ATC Site: 10047 – Portland ME, ME (225 Riverside Industrial Parkway, Portland, ME 04103)

Subject: Verification of Modification Installation for City of Portland Building Permit ID 2017-01925

TOWER-POST MODIFICATION SPECIAL INSPECTION GUYED TOWER

275 FT GUYED TOWER MODIFICATIONS

SHEET NUMBER: REVI	SION:
SHEET NUMBER: REVI	SION.
A-3 (ו

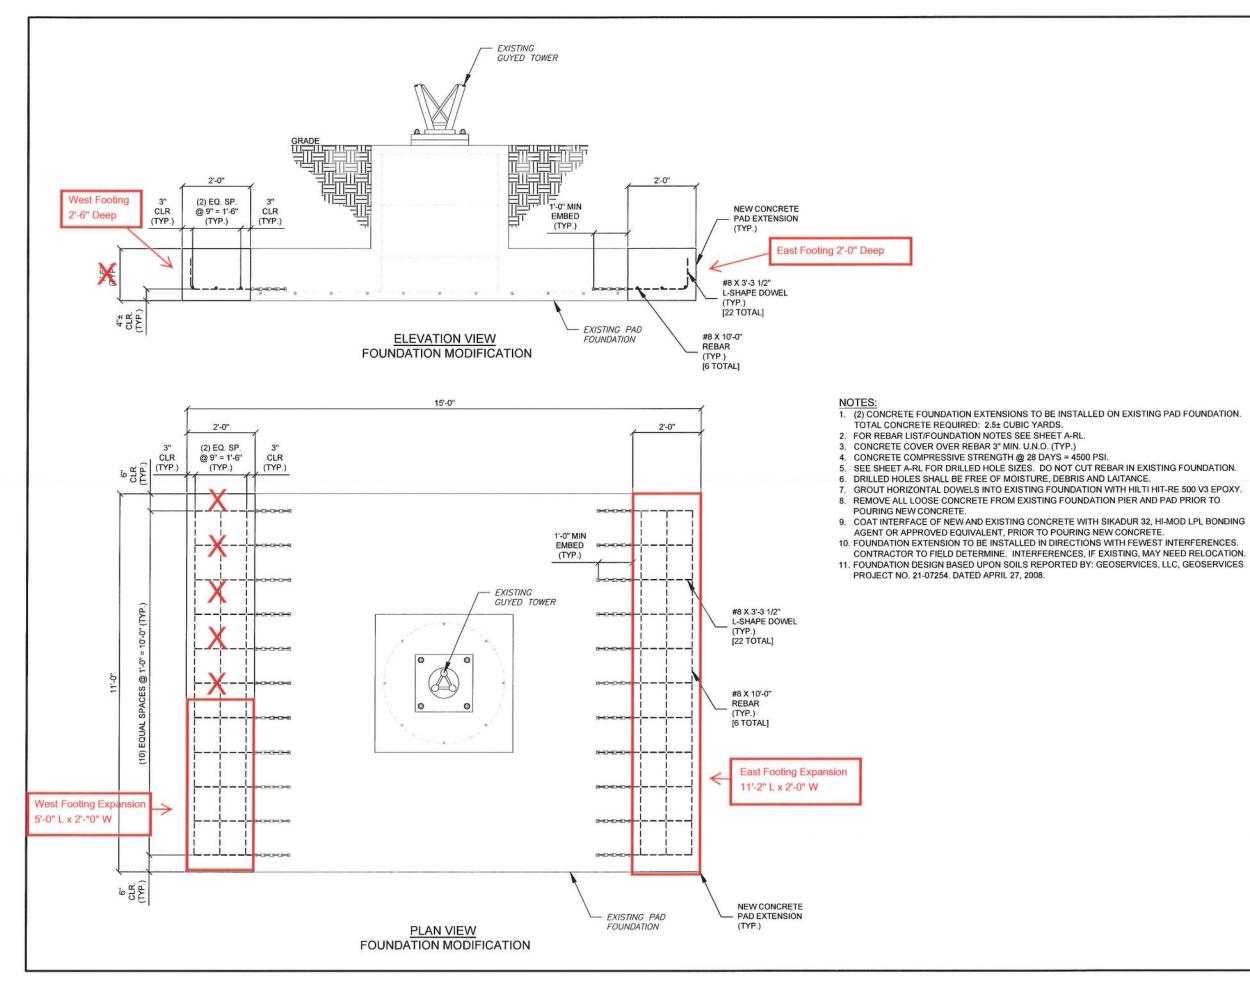
They can install 2' to one side with the full length. How long can they install on the other side up to the edge of the existing foundation? Is the existing foundation $11'8'' \times 11'8'' \times 2'6''$?

They can mod the East & West sides or the South & North sides. The East or South side will have full length x 2-ft wide and the North or West side they will have partial length, up to the edge of the building x 2-ft. They have to provide the measurement of the partial length on the North & West side so this can be reflected in the as-built.

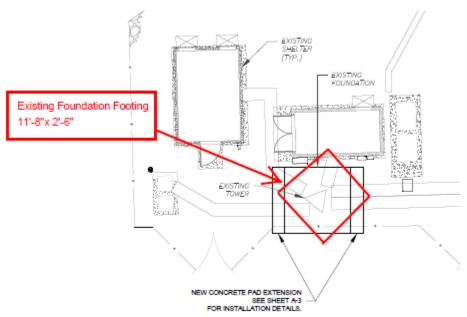
Please advise. The existing foundation is in rough shape.

Jon, I am going to give you a call from my desk phone take a look want to see what the engineer wants to do about the rebar embedment as they are looking for 12" deep and the foundation at bottom slopes in 4-6".

Please use the full 30".

The sloping is unexpected and unwelcome. That said, the original drawings only had the mat at 18" thick with the base at 4' below grade.

The rebar needs to be installed 12" into competent concrete. The may need to use longer bars to make this work.
